Report to the Future Melbourne (Planning) Committee

Agenda item 6.1

**Planning Permit Application: TP-2015-81
1-3, 5, 7, 9-11 Epsom Road, Kensington**

15 May 2018

14/09/2017
 PROPOSED GROUND FLOOR PLAN
 1:200, 1:100

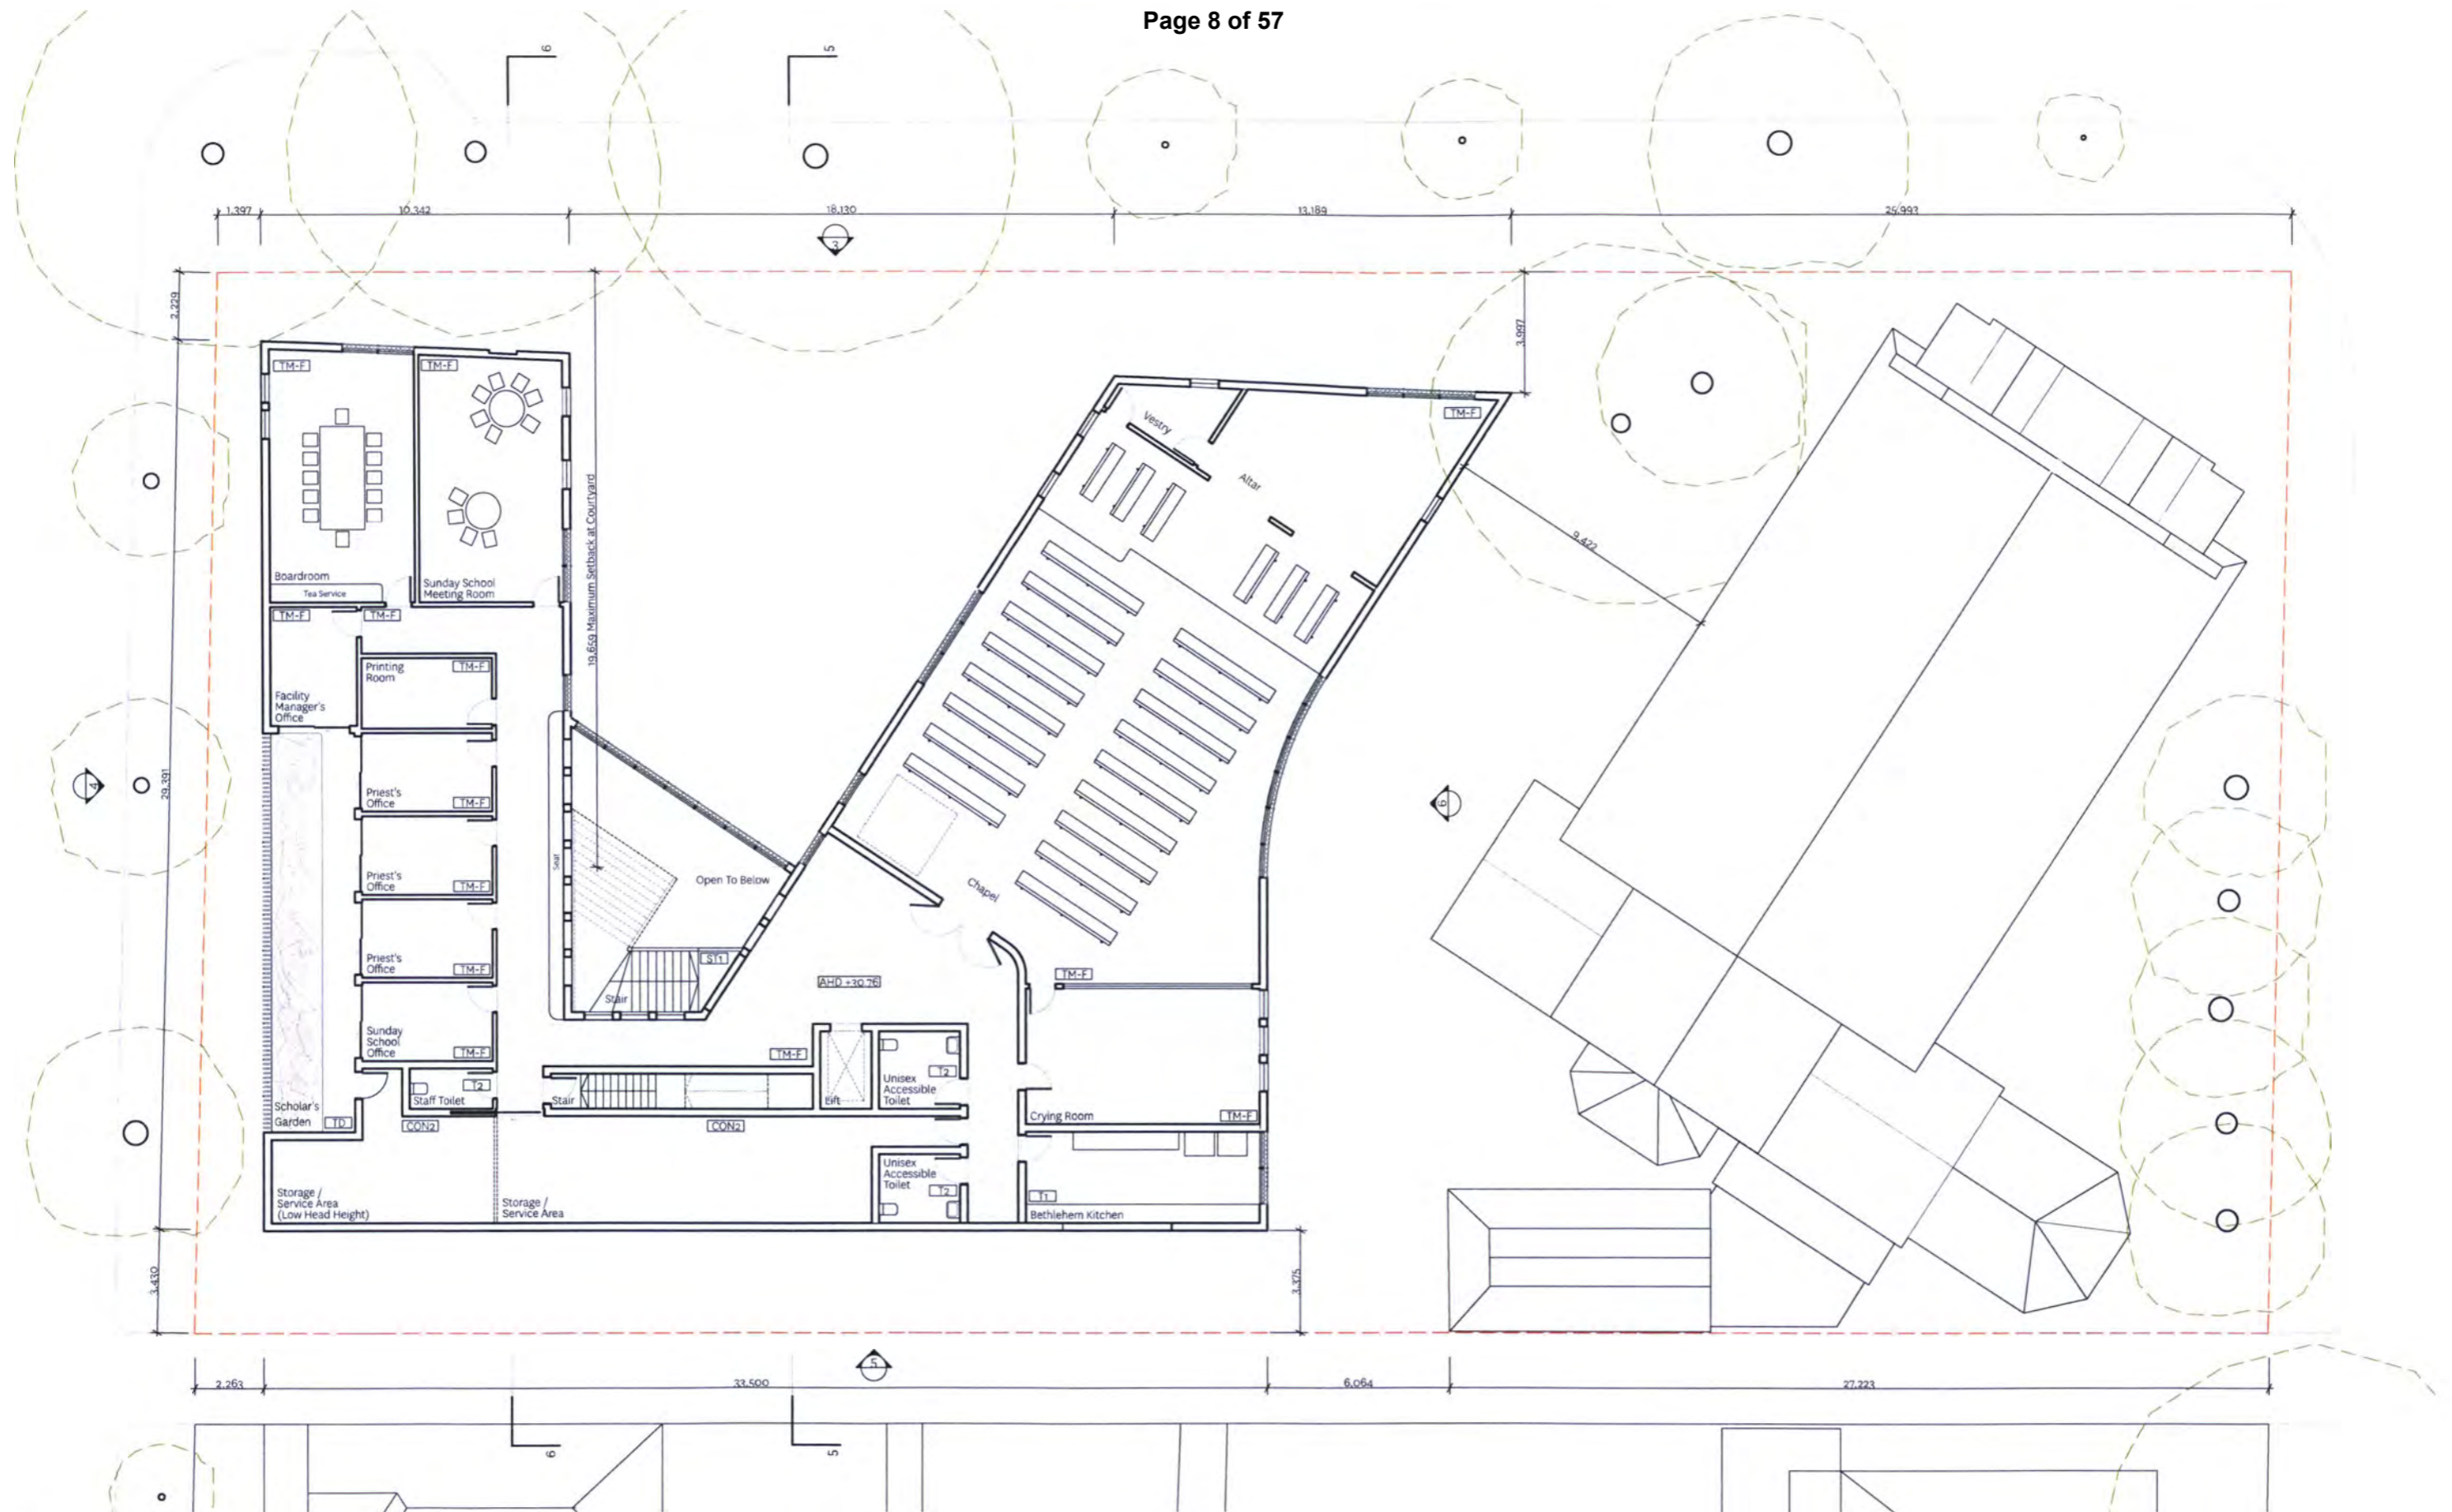
We have some concerns around the planting strategy in conjunction with the colonnade in its current form where it interfaces with Epsom Road and The Ridgeway. The sections show planting to 2m high which would create unsafe spaces within colonnade, and dense tree planting.

We require the revision of the landscape strategy to ensure any hedge style planting is limited to 1m in height to allow sightlines. Clean trunked trees should be placed to allow for clear views through to the courtyard and colonnade on the Epsom Road frontage.

It is agreed that a lowering of planting height between columns would be an appropriate outcome to ensure that improved visual connection and surveillance can be achieved. This could form a condition on any permit granted – **refer recommended Condition 4.**

4. Prior to the commencement of the development, an updated Landscape Report prepared by Openwork Pty Ltd must be submitted and approved by the Responsible Authority. This report must:
 - a. Include submission of detailed landscape plans that confirm the development of the concept described in the Landscape Report into implementation documents;
 - b. Address soil volumes, depths, drainage and irrigation provision;
 - c. Ensure any hedge style planting is limited to 1 metre in height to allow sightlines. Clean trunked trees should be placed to allow for clear views through to the courtyard and colonnade on the Epsom Road frontage.

TPO3.2 14/09/2017
PROPOSED BUILDING ELEVATIONS
1:250, 1:200

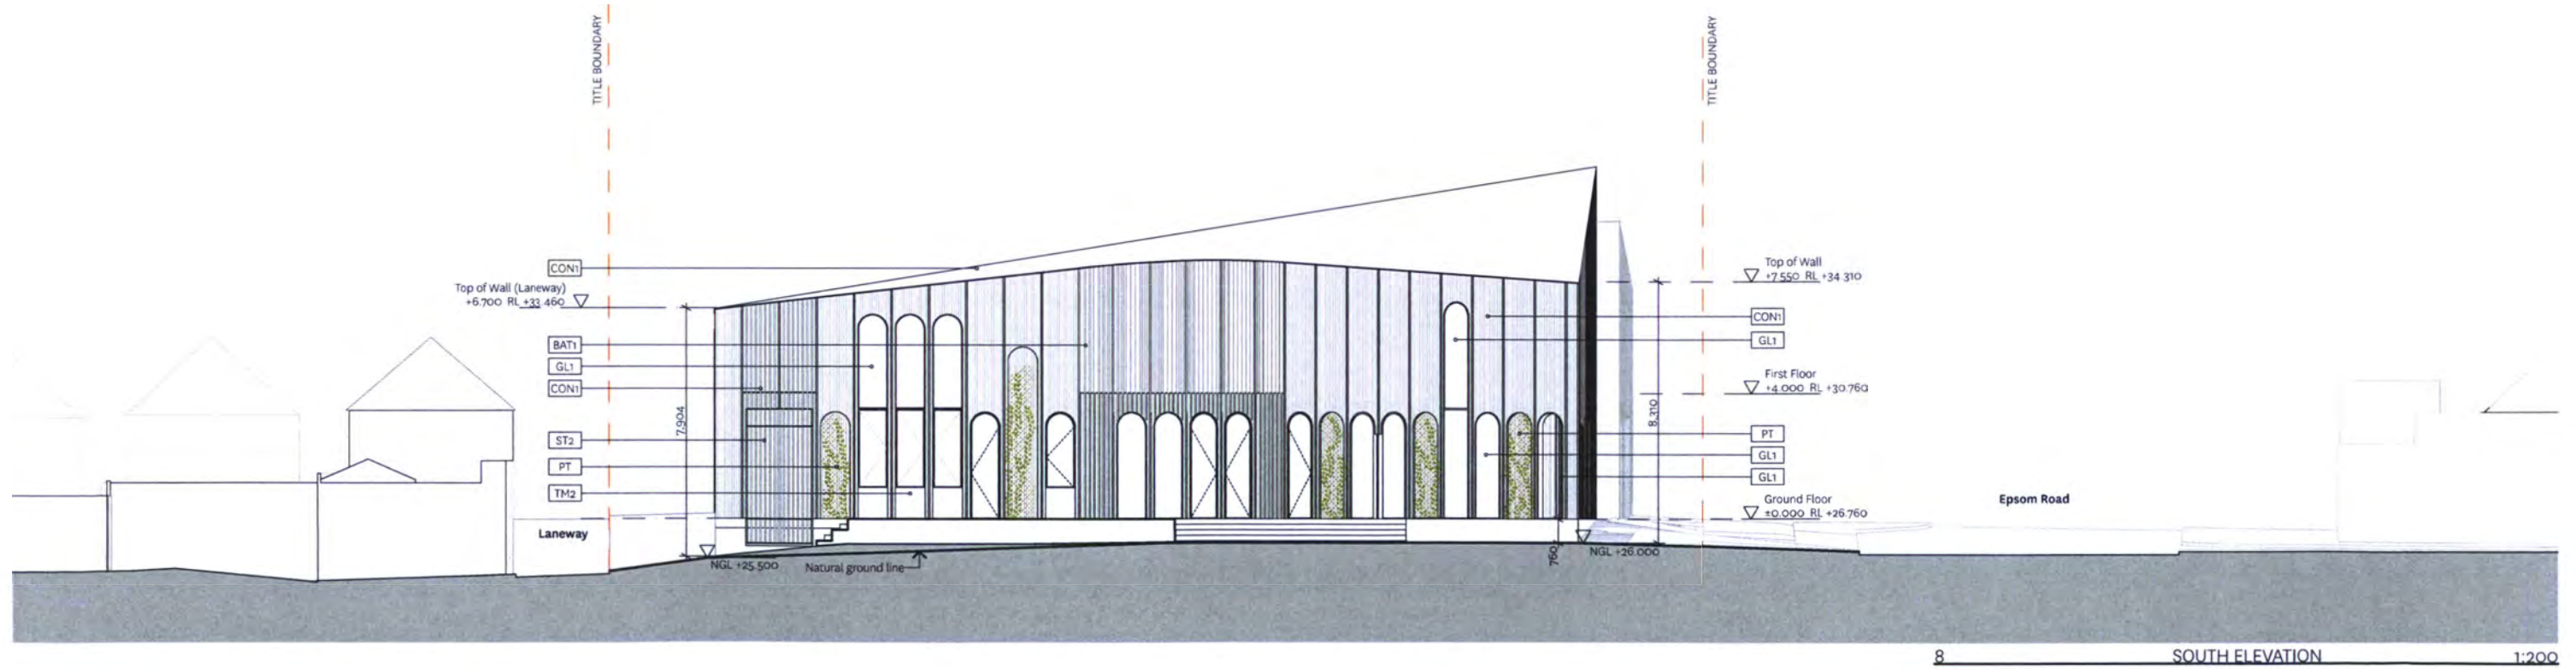
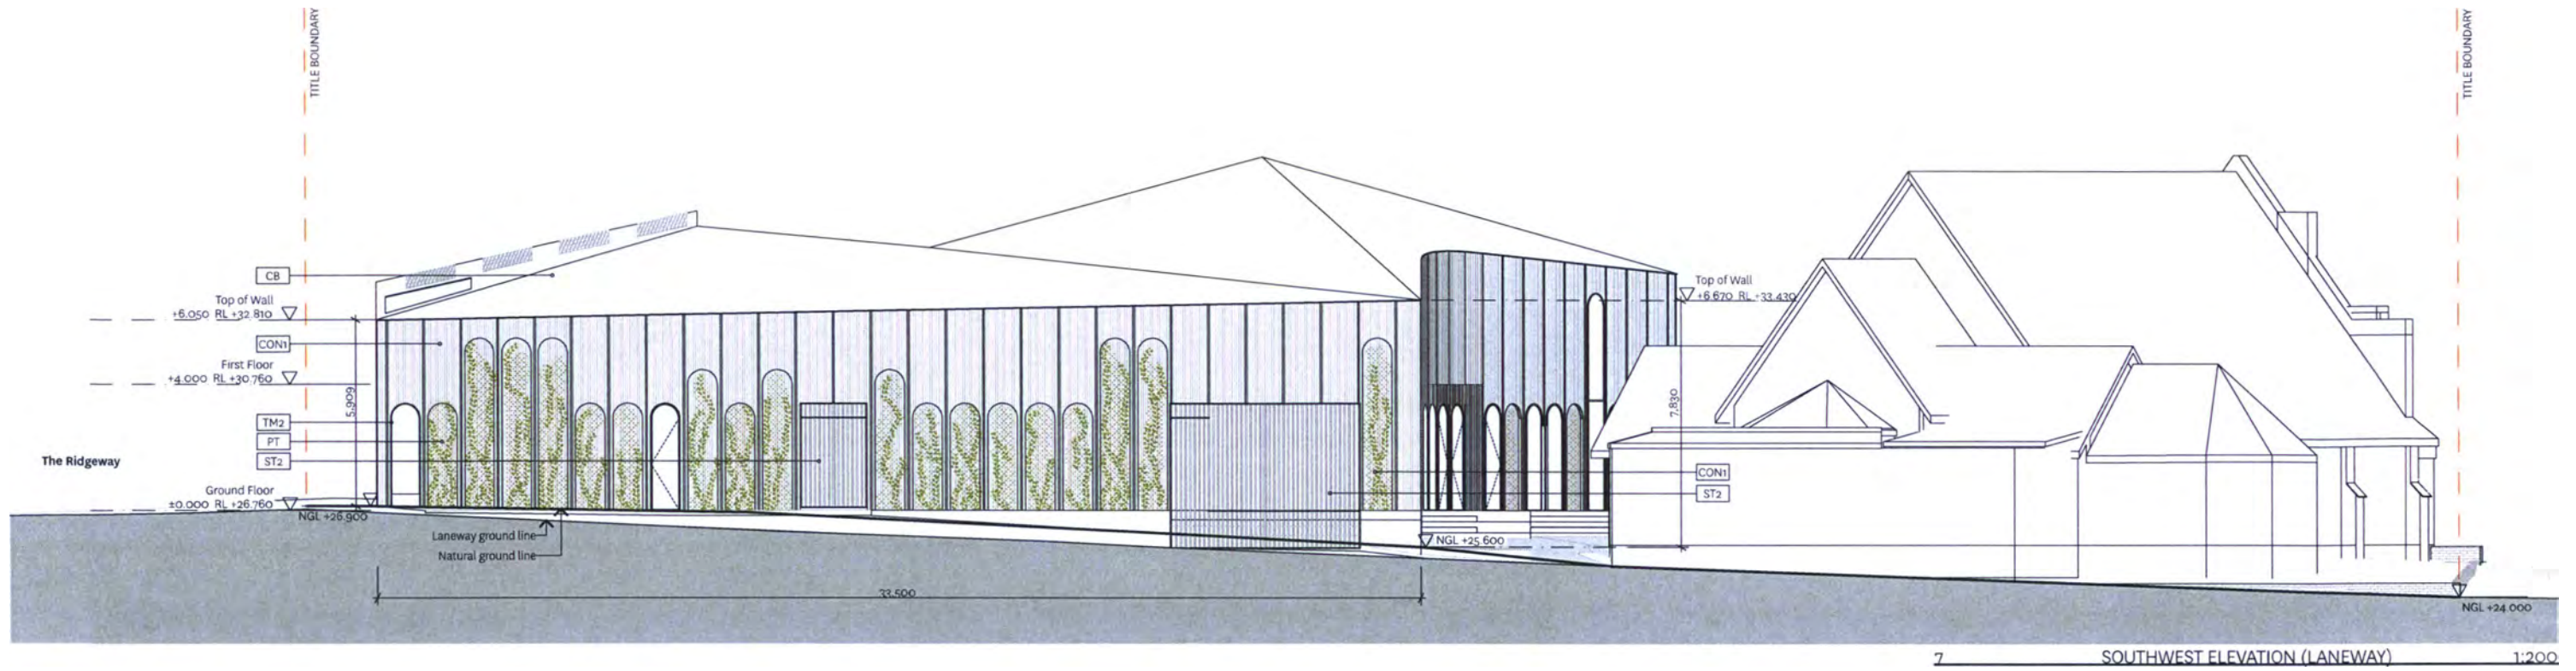
In response to the above, subtle increases in the taller pitch point heights in the order of 1–1.5 metres and an infill break between the south-west axis wing would respond to the feedback above and would ultimately result in a positive outcome for the following reasons:

- a) Incorporation of lighting within the colonnades.
 - b) An increase in the two central corners of the Epsom Road elevation in the order of 1.5 metres to provide a better vertical proportion and relationship to the existing Church.
